HISTORIC AND DESIGN REVIEW COMMISSION

HDRC CASE NO: 2017-467
ADDRESS: 423 N HACKBERRY ST
LEGAL DESCRIPTION: NCB 576 BLK 15A LOT N 30.32 FT OF 12
ZONING: RM-4 H
CITY COUNCIL DIST.: 2
DISTRICT: Dignowity Hill Historic District
APPLICANT: John Brearley
OWNER: John and Irene Brearley
TYPE OF WORK: New construction of a 2-story single family home
REQUEST:

The applicant is requesting conceptual approval to construct a new two-story single family home on the vacant lot at 423 N Hackberry.

RIGHT ELEVATION

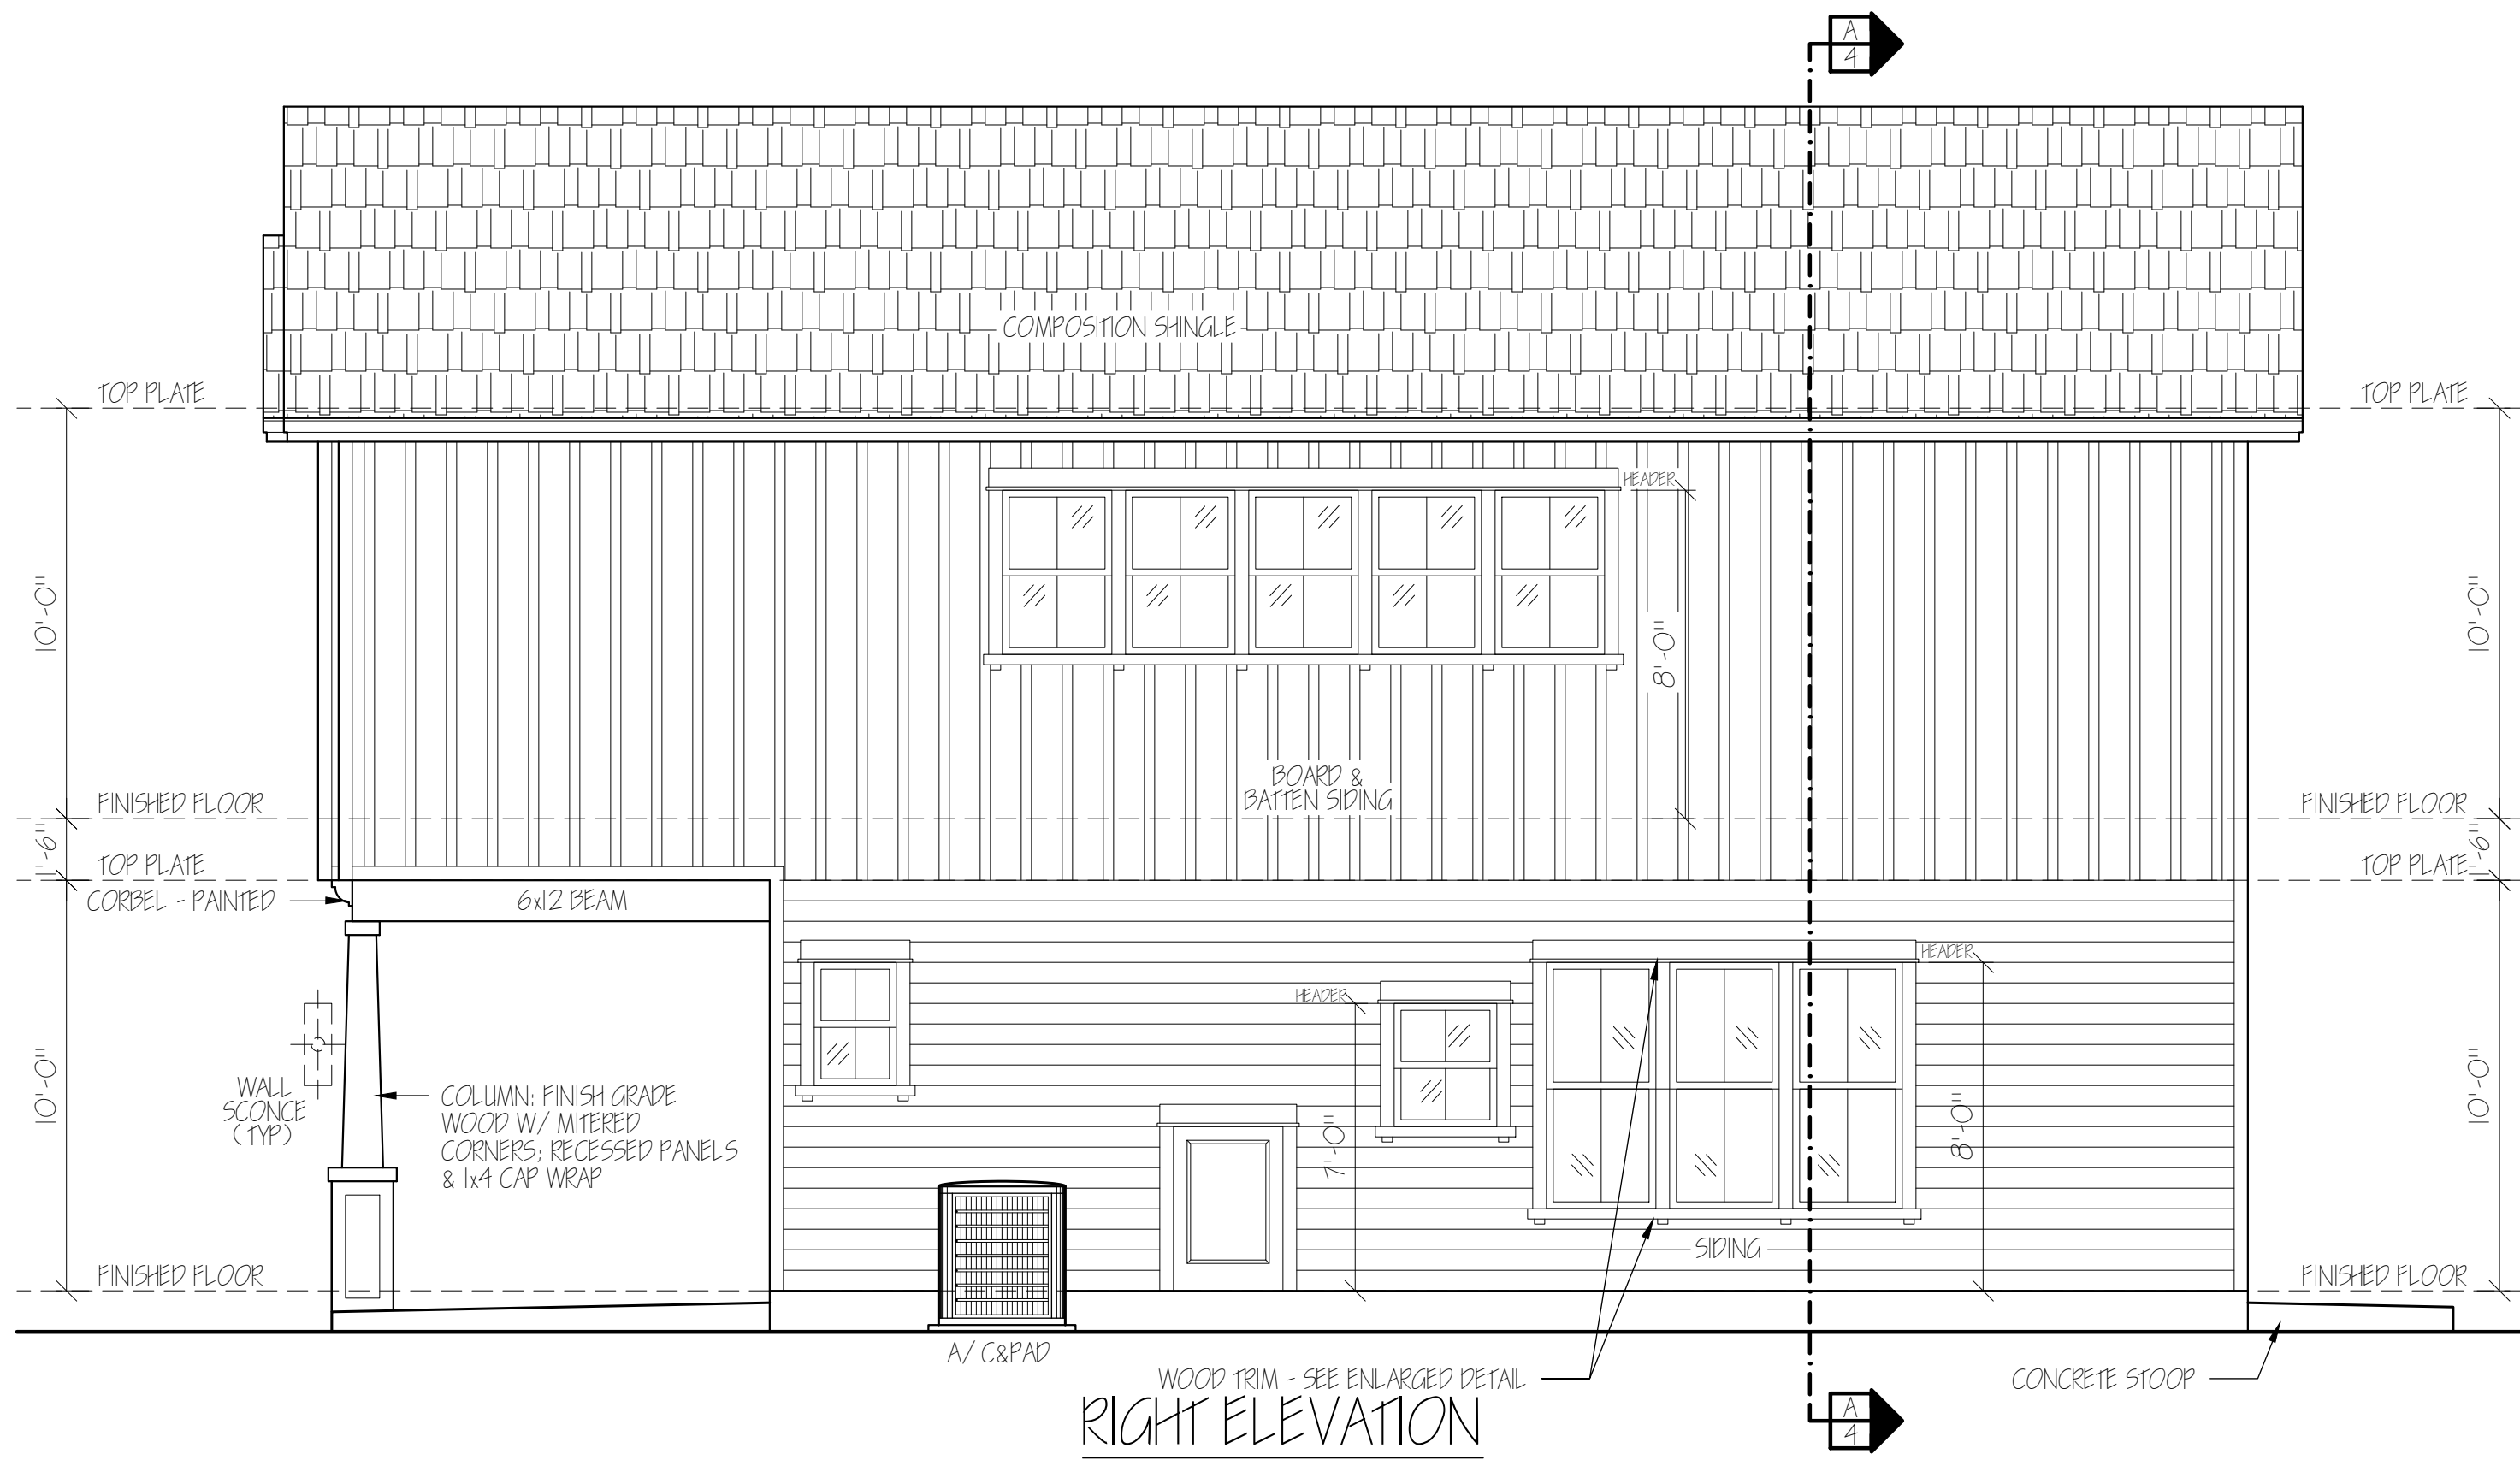
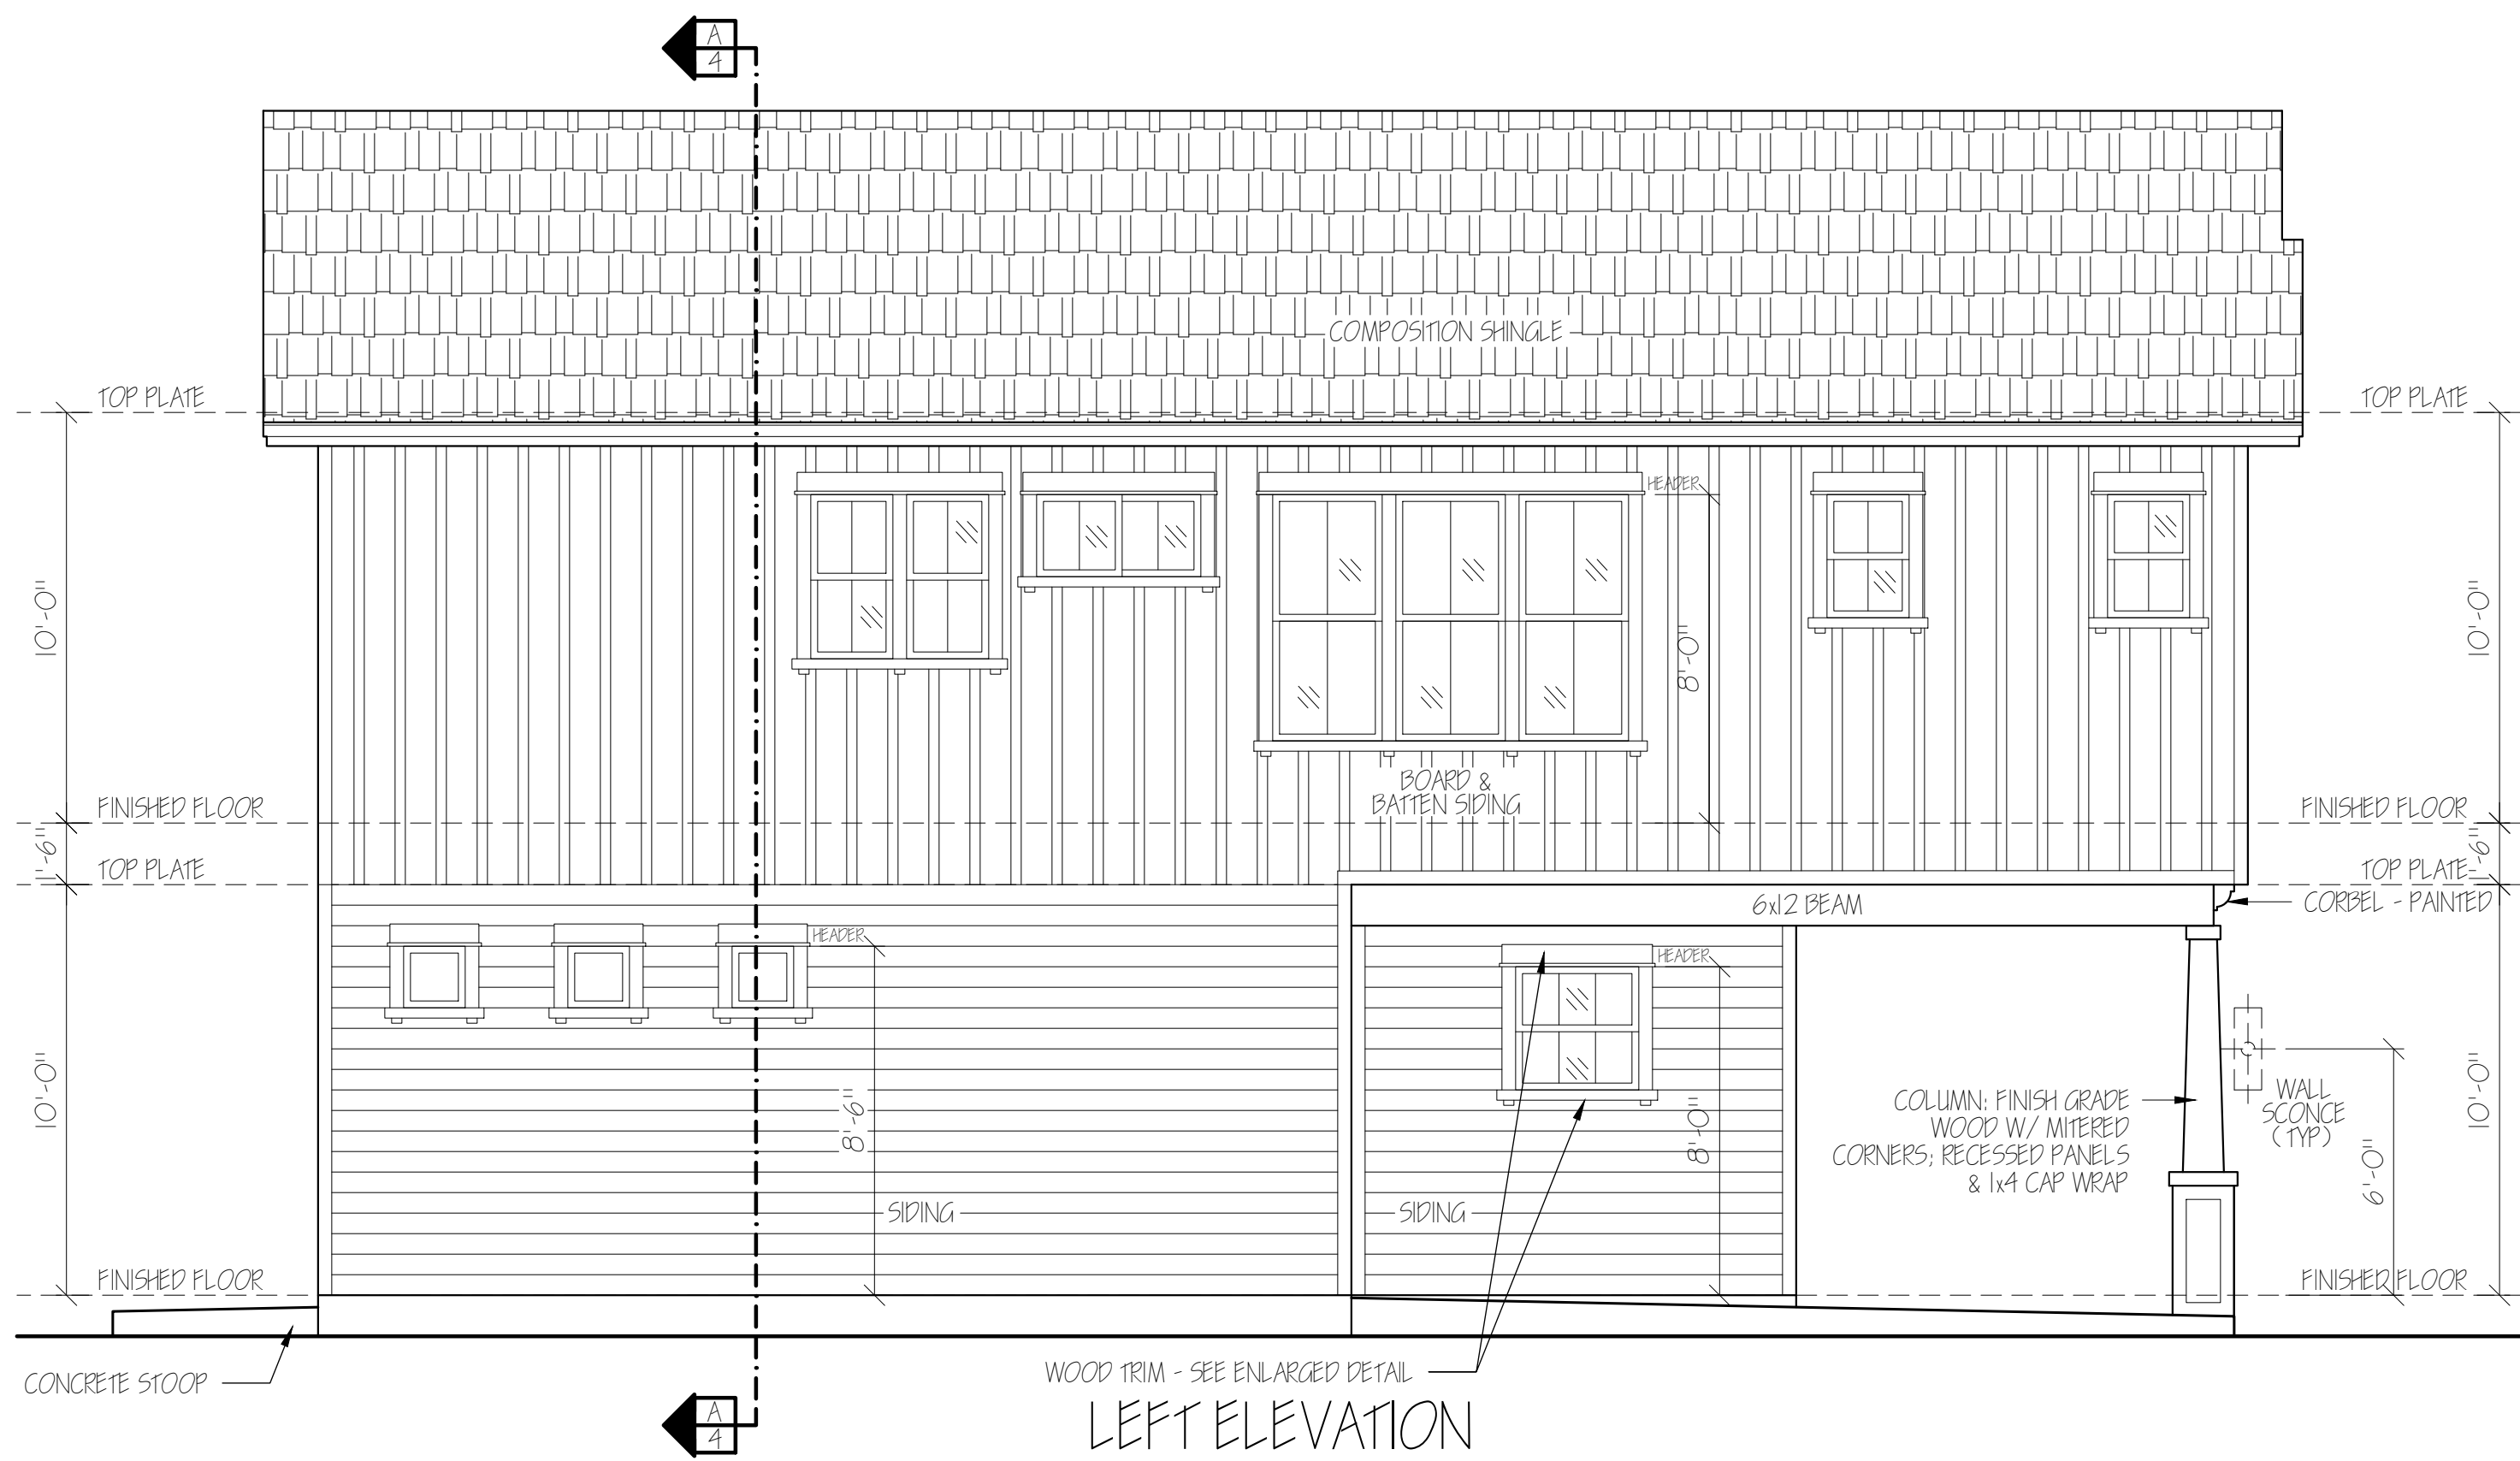
those found on historic structures in regards to location and size with the exception of the right and left elevations, which feature several small fixed windows that are not consistent with the OHP Window Policy Document or historic fenestration precedents in the district, as well as a series of ganged windows with minimal trim separation between them. All proposed window detailing can be modified to relate closer to historic examples, such as the use of approximately six inches of separation between double windows. Each window should be inset at least two (2) inches within walls to ensure that a proper façade depth is maintained.

COMMENTS/CONCERNS: Updated drawing - includes
small front balcony. Plus a fake window
under carport. Issue of no windows on one
side; issue of a fake window in new construction.
Needs to have windows. Small window in bathroom,
not large enough - focus on pattern, consistency.
Fewer windows placed strategically.
Balance pattern, rigidity to window placement. →

4. That the proposed driveway extends along the side of the proposed new construction as noted in finding p.
5. That the applicant introduces window sizes and proportions that are more consistent with the Historic Design Guidelines, the OHP Window Policy Document, and adjacent historic structures to the right and left elevations as noted in finding i.
